OCONEE NUCLEAR STATION, UNIT 1

Amendment No. 2
License No. DPR-38

CHANGE NO. 12 TO TECHNICAL SPECIFICATIONS FOR FACILITY LICENSE NO. DPR-38

SAFETY EVALUATION BY THE DIRECTORATE OF LICENSING

OCONEE NUCLEAR STATIC
 STATION ORGANIZATION
 FIGURE 6.1-1

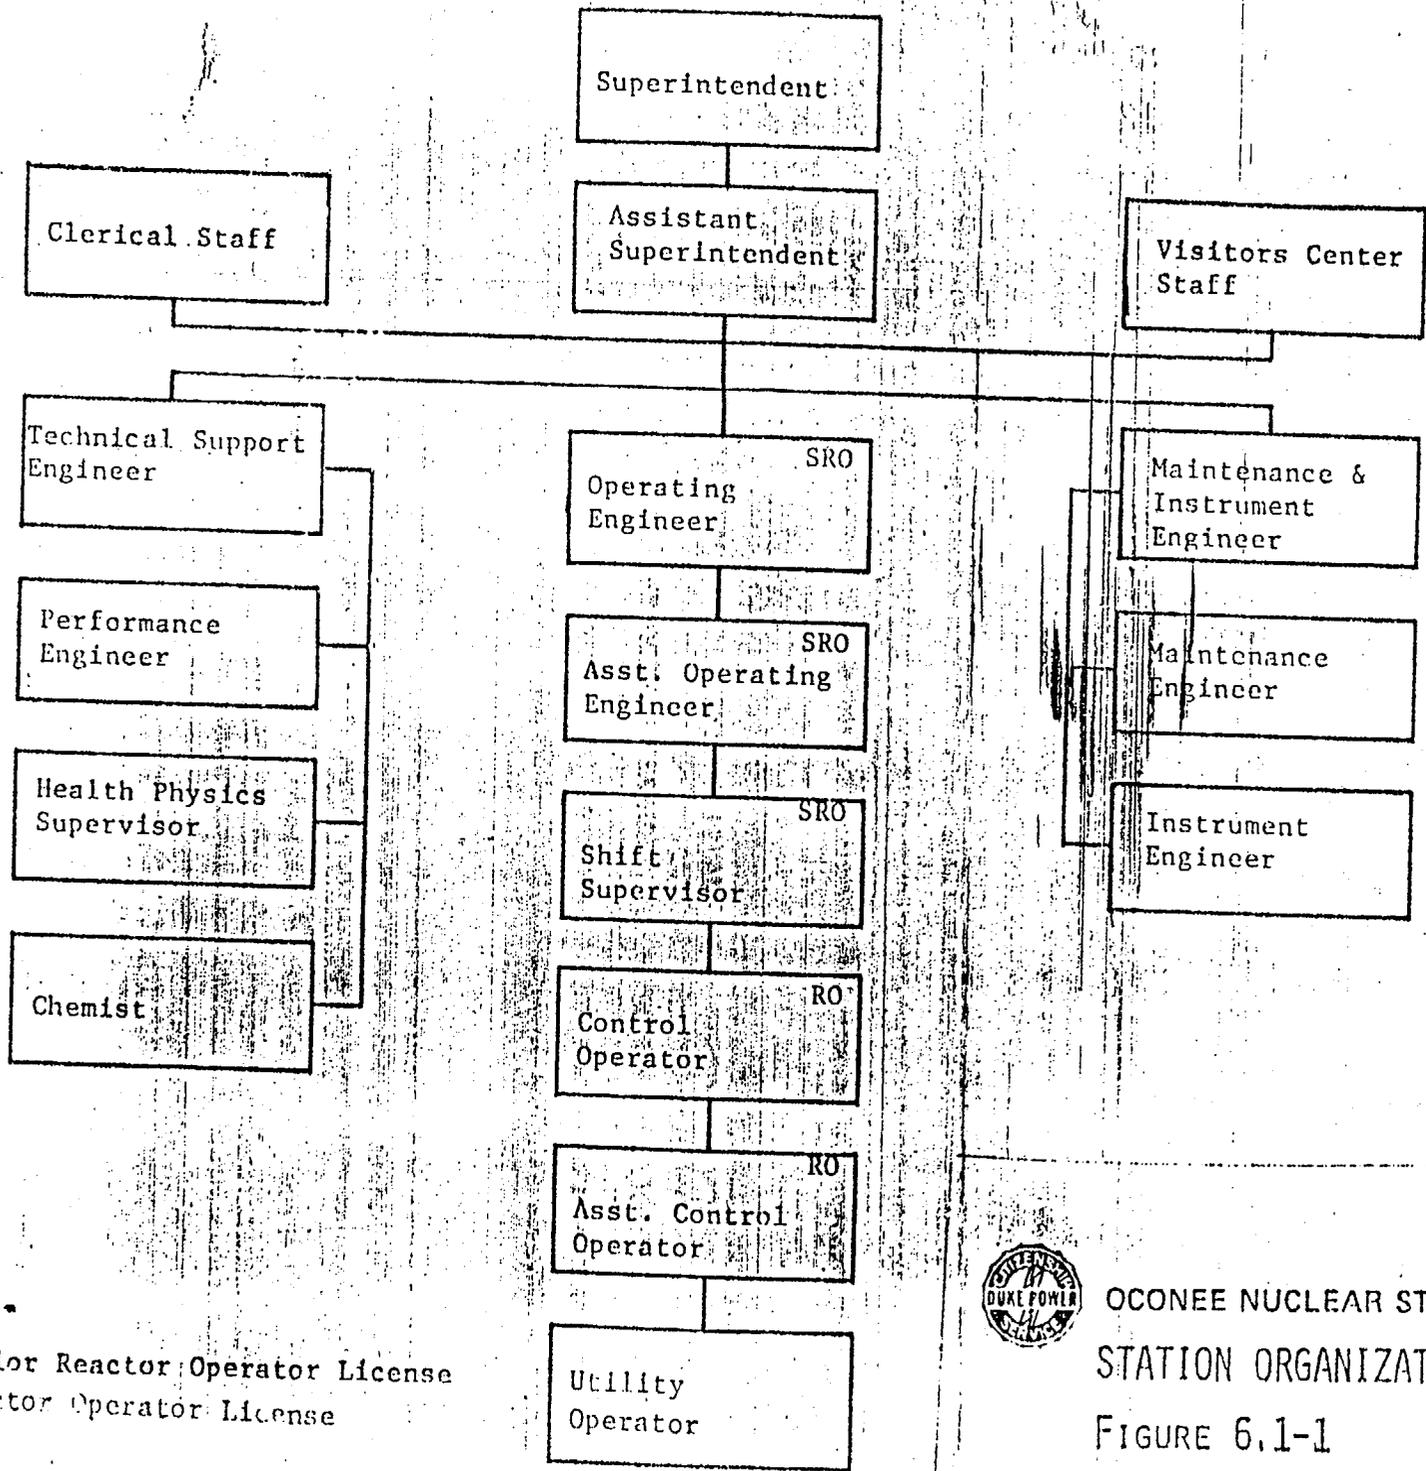
Replace Figure 6.1-1 with the attached.

- (1) Instrument and control personnel will be moved from the Technical Support Group and will report to an Instrument Engineer who in turn will report to the Maintenance and Instrument Engineer.
- (2) Health physics personnel will report to a Health Physics Supervisor and chemistry personnel will report to the Station Chemist. Both supervisors will report to the Technical Support Engineer. At present, chemistry and health physics personnel report to the same supervisor.
